A66 Northern Trans-Pennine project

TR010062

8.2 Change Application: Consultation Report - Appendix H: Proposed Changes Consultation Brochure

Proposed changes consultation

Amendments to the Order Limits within Ministry of Defence land. Increase in the land required to accommodate design changes to ensure the operational requirements of the site are not compromised.

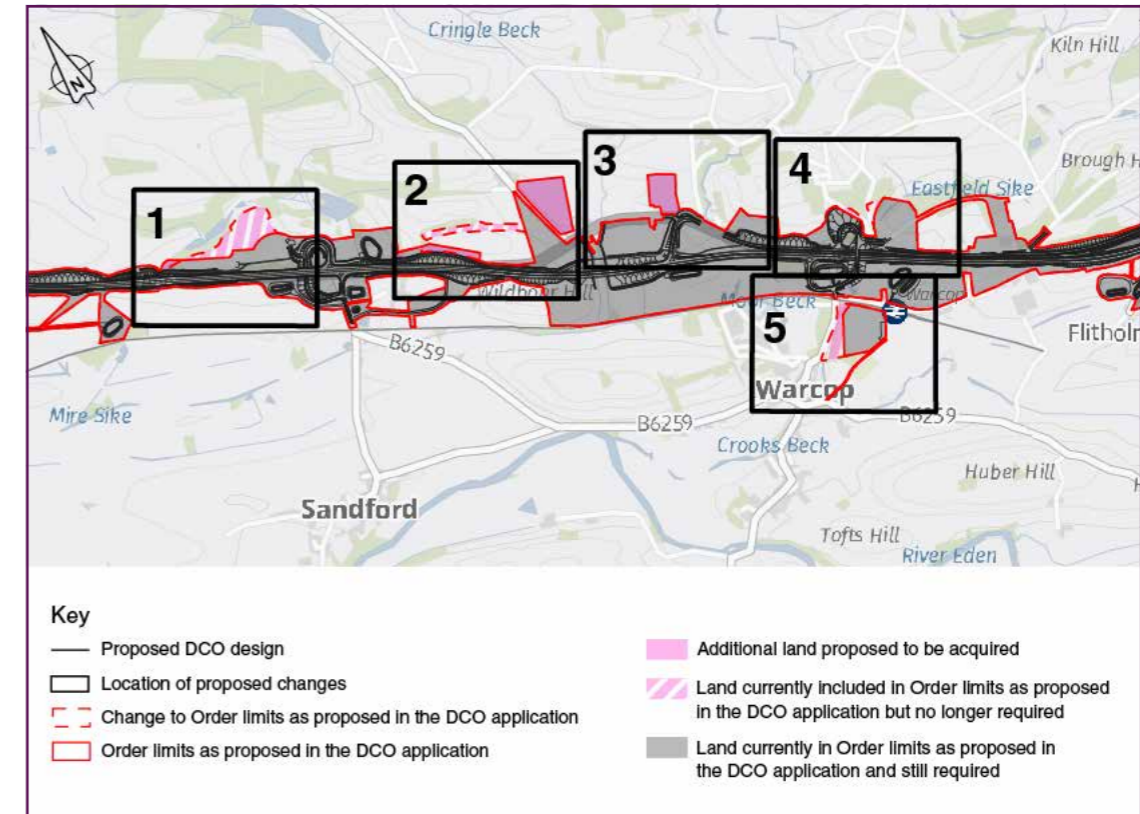
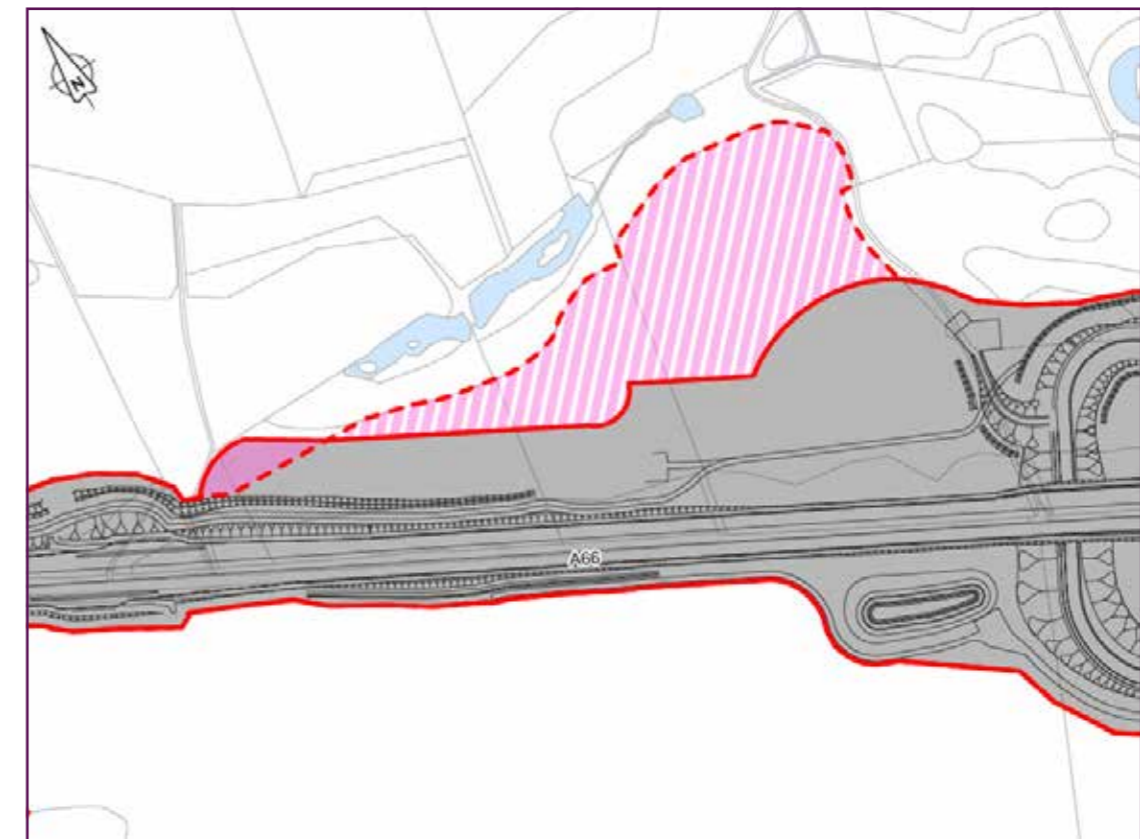
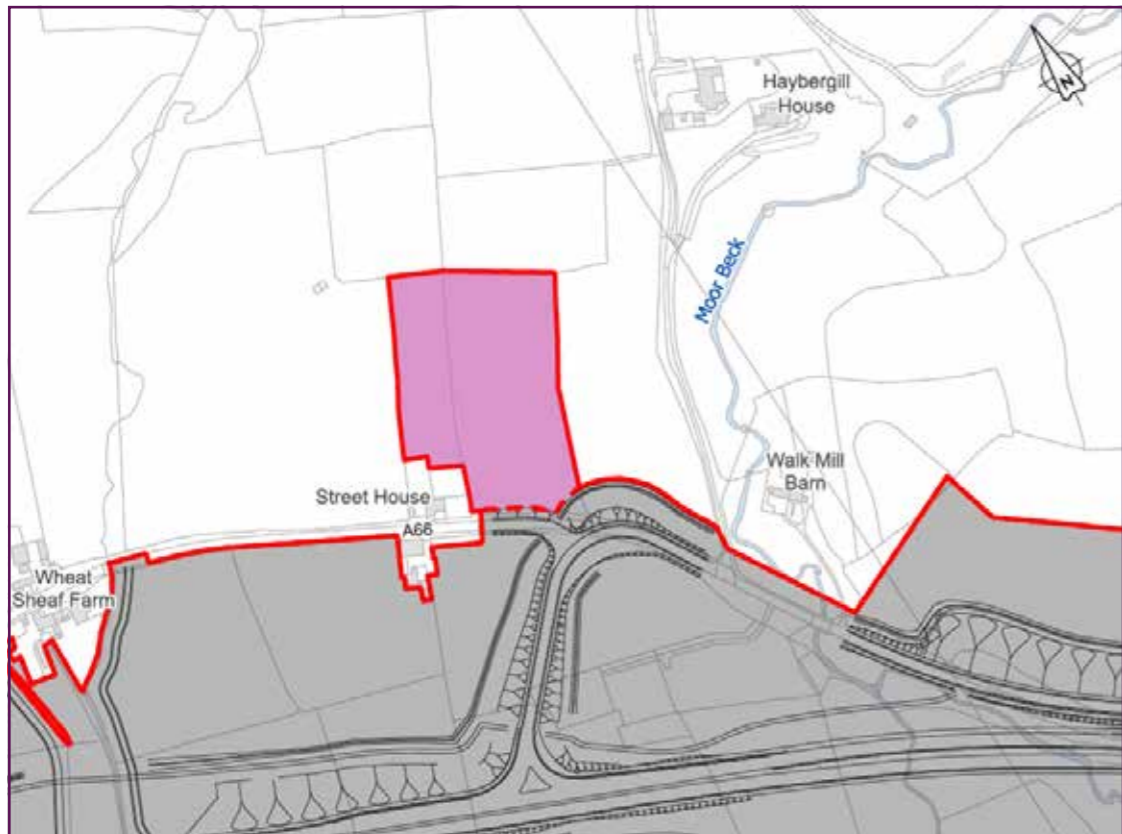
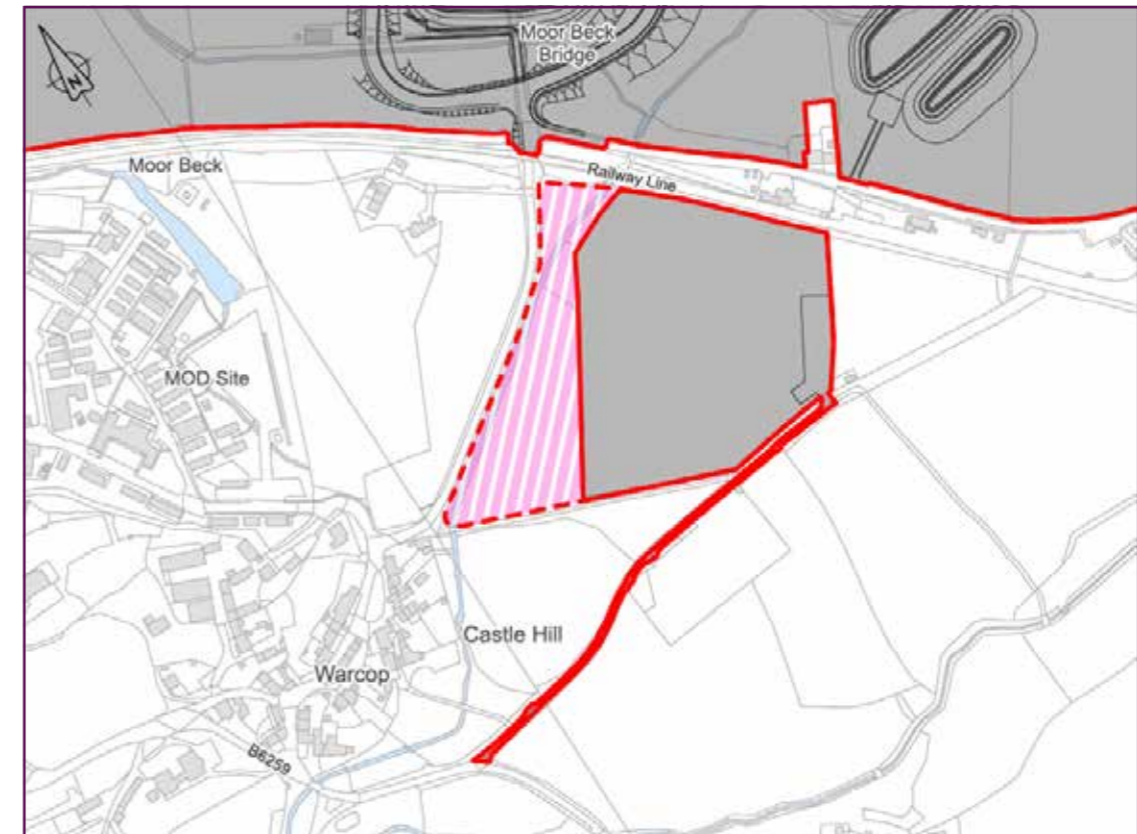
In our ongoing discussions with the MoD, they have told us that some of the land we have proposed to use for mitigation for the scheme is now required for their operational purposes, including the training of troops, which is fundamental to the functioning of the site. They have explained that areas north of the A66 are tactical land and particular locations are of strategic importance.

The MoD have suggested some alternative locations outside of the Order Limits where mitigation planting will not impact on the operations of their site. The changes are shown in the plans. This would require a change to the Order Limits for our DCO application.

This plan helps to compare the DCO design with the proposed change at Langrigg. The DCO design is shown in dotted black with the proposed change (in principle) shown in colour. Further detailed design of aspects such as ponds and accesses continue to be developed.

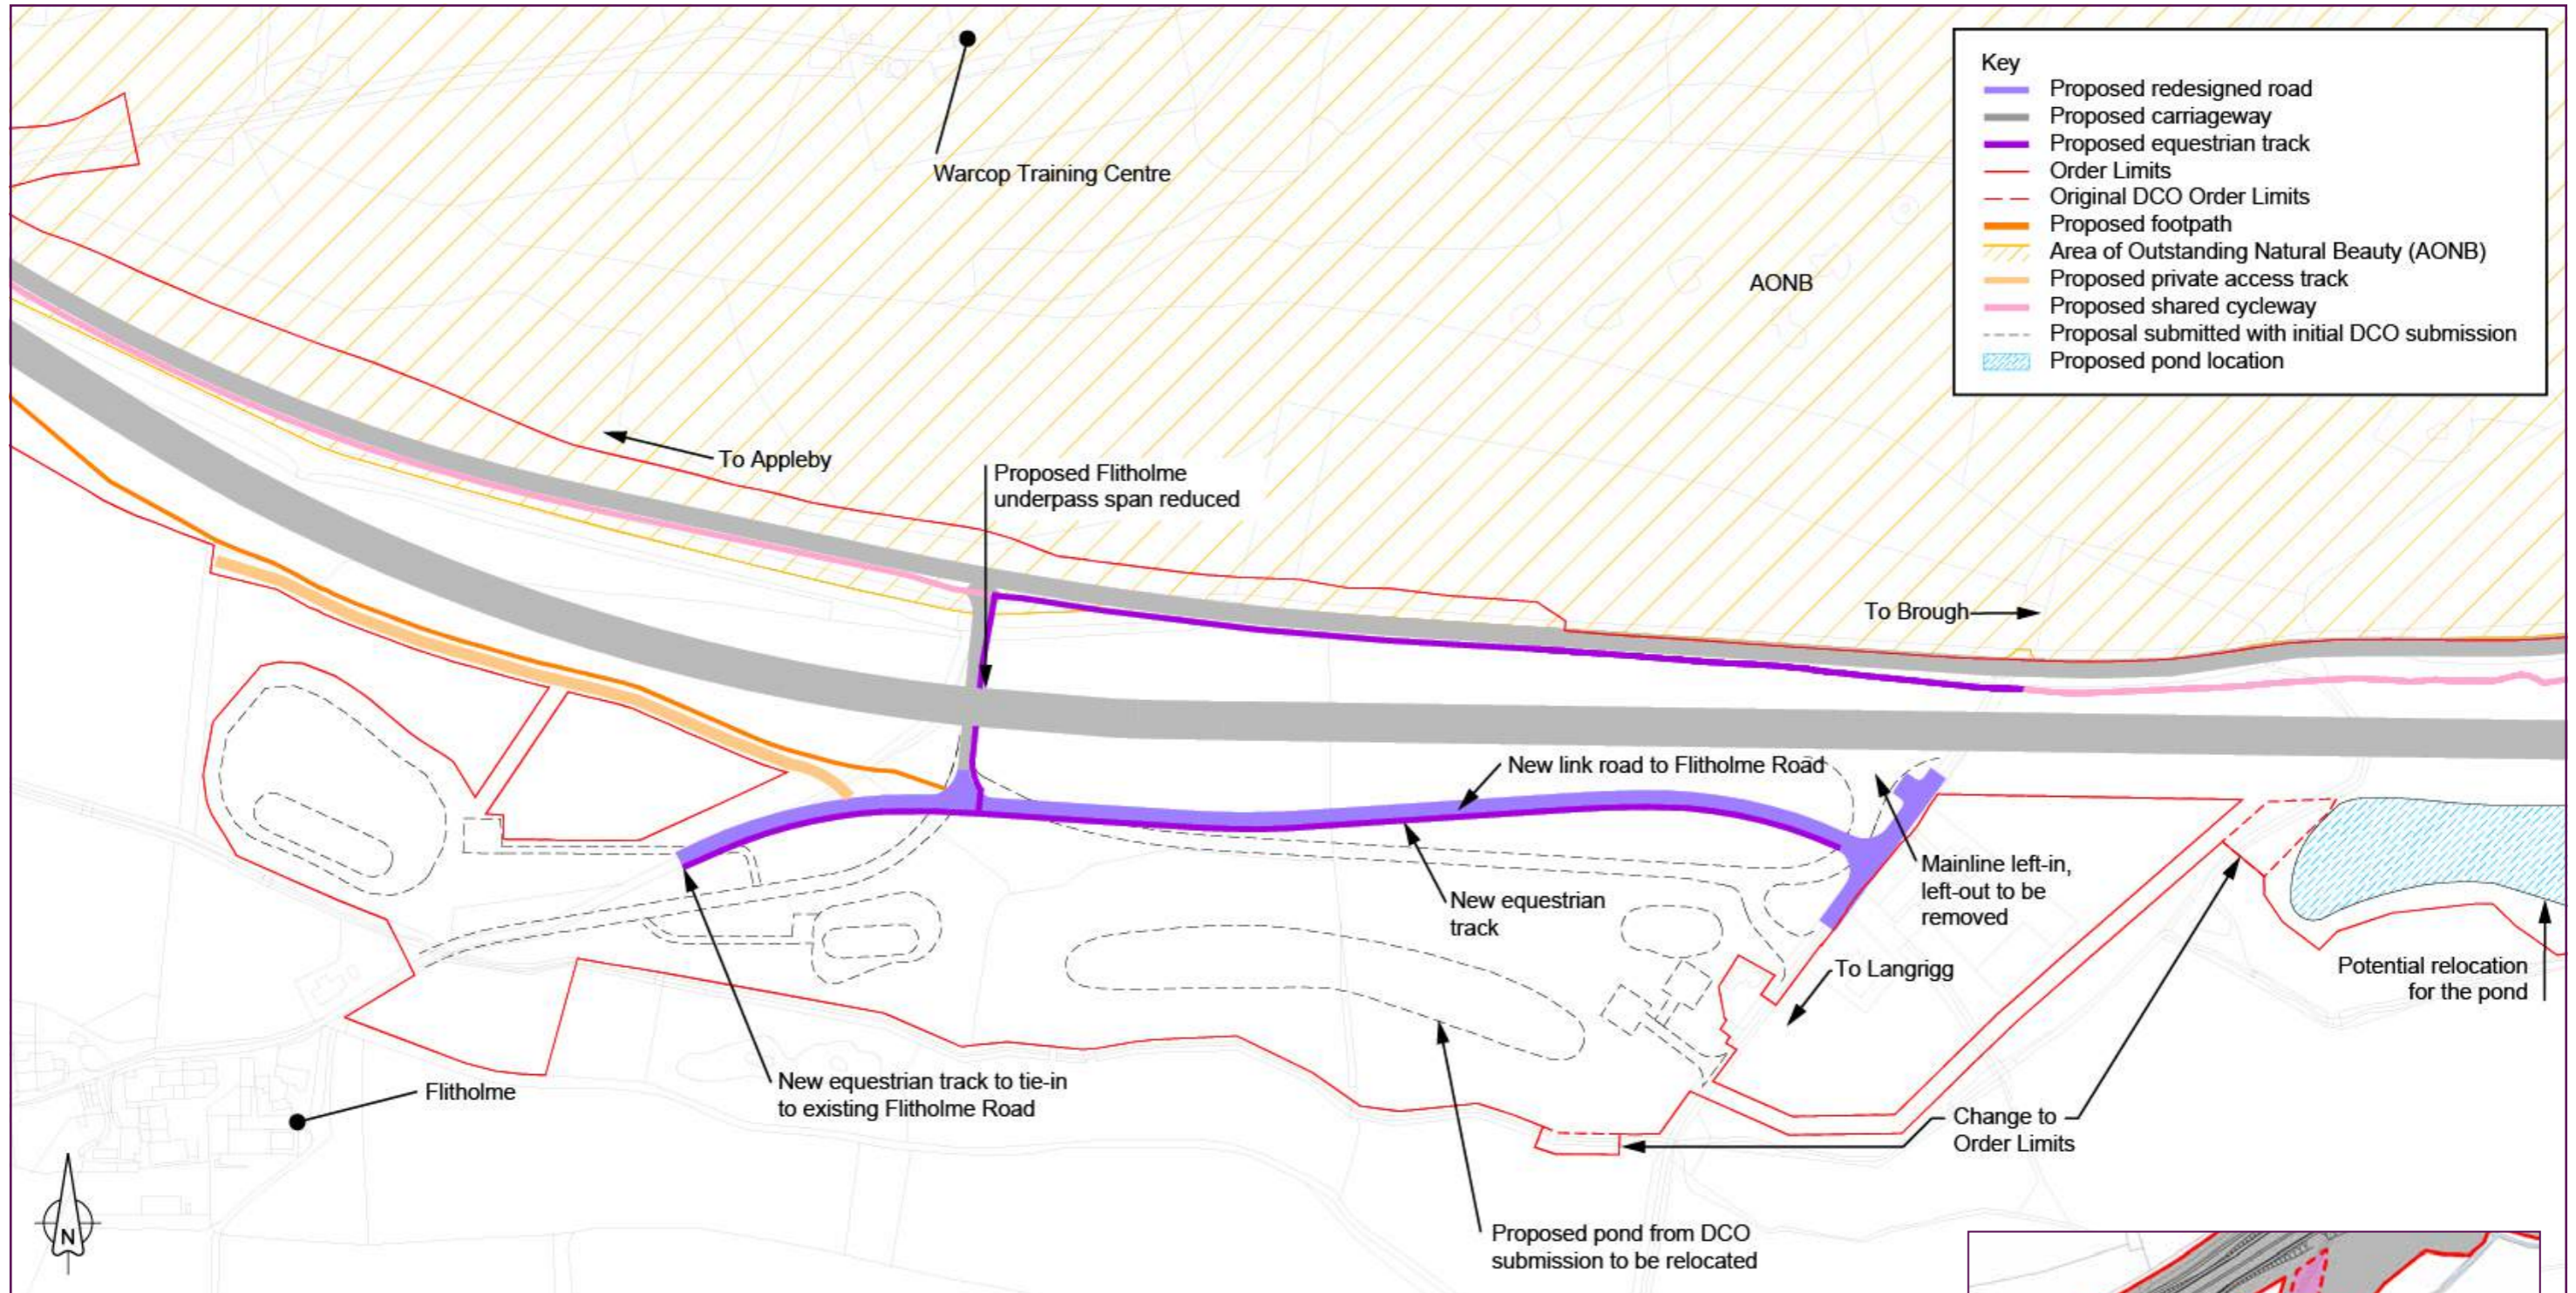
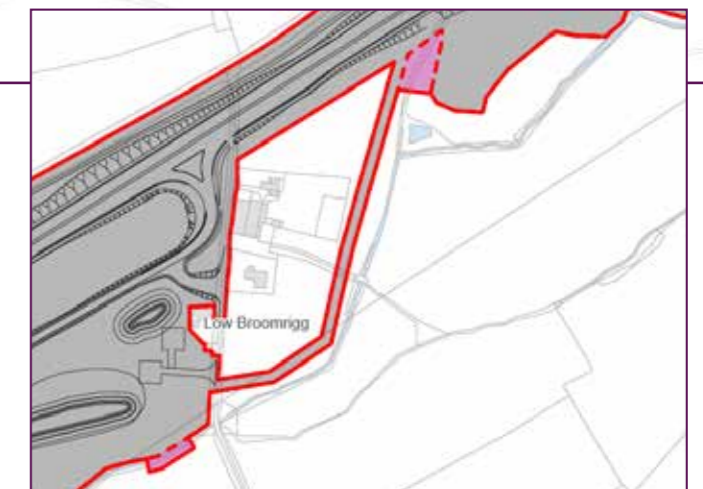
By tying in the Flitholme Road junction 100m to the north of the bridge over Lowgill Beck, we can also reduce impacts on residents in that area.

The removal of the Langrigg junction allows the link road and associated infrastructure to move north. The relocation of the largest balancing pond away from an area of fen, which is considered a priority habitat, provides the opportunity to reduce environmental

Proposed change to Limits of Deviation at the new Kemplay Bank junction. The widths of the proposed changes to the LODs are shown on the image above

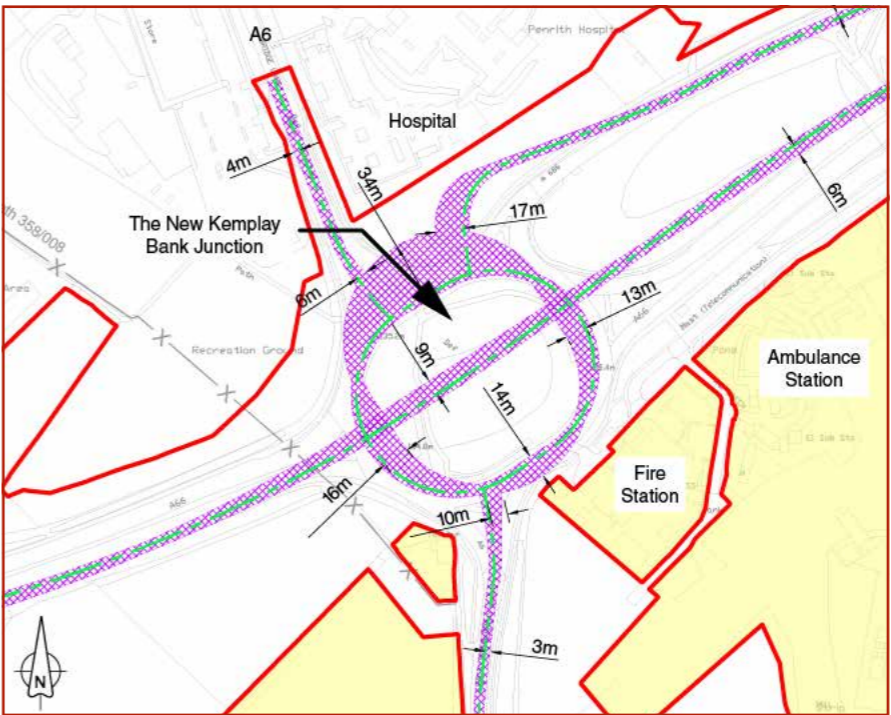
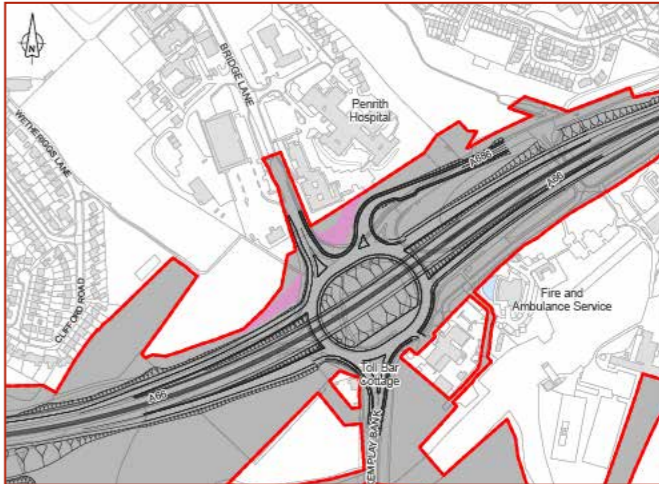
This change will help us to reduce the time it takes to build the Kemplay Bank junction, reducing diversions and disruption caused to local drivers over this long build period. We think this change may help to reduce construction by approximately nine months.

This change may affect the amount of land we need to acquire permanently and use temporarily, particularly on the north side of the roundabout, where we would need to acquire more land permanently to accommodate the changed shape of the roundabout. This would be the case both at the rugby playing fields where an additional slither is required and at the hospital grounds. We are in discussions with landowners around how we might mitigate these effects.

DCO-28 – Realignment of local access road to be closer to new dual carriageway east of Bowes

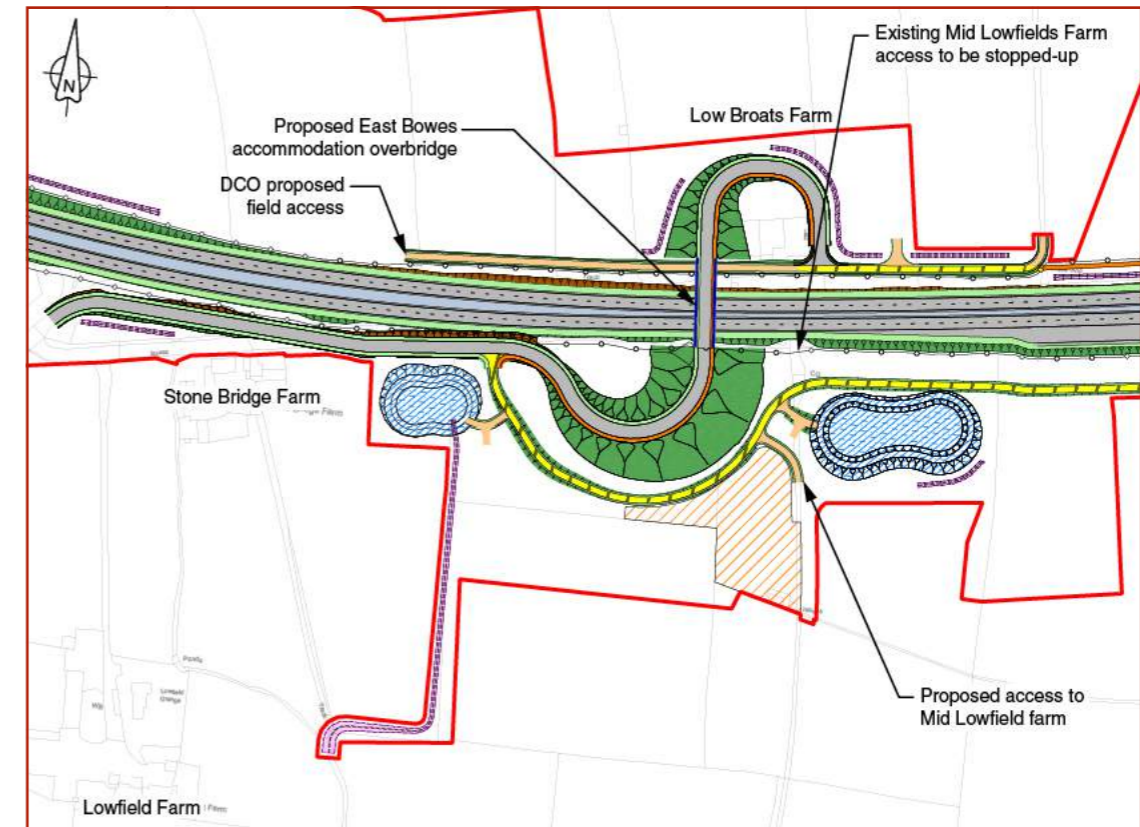
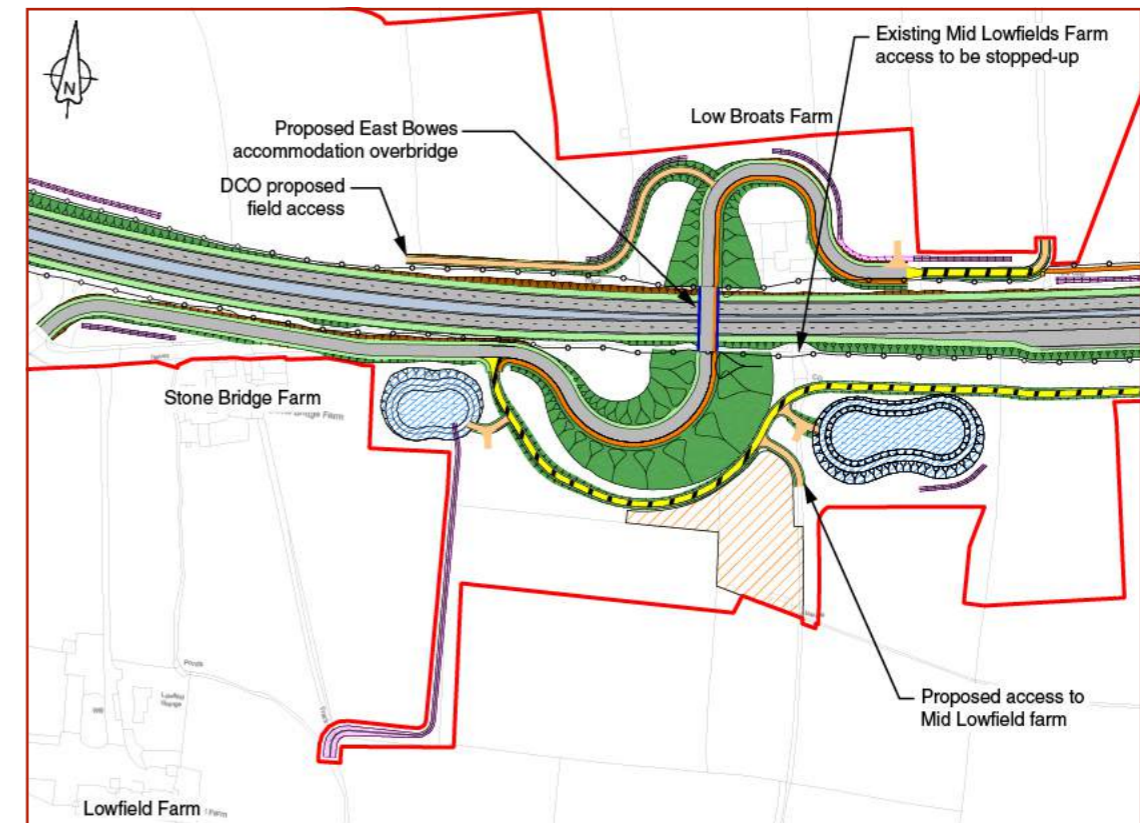
East of Bowes our DCO design includes separation between the dual carriageway and a private access track to help us build the road. Early detailed design has determined that this provision is no longer required. An increase in the lateral LoDs will enable the overbridge design to be simplified and moved closer to the dual carriageway.
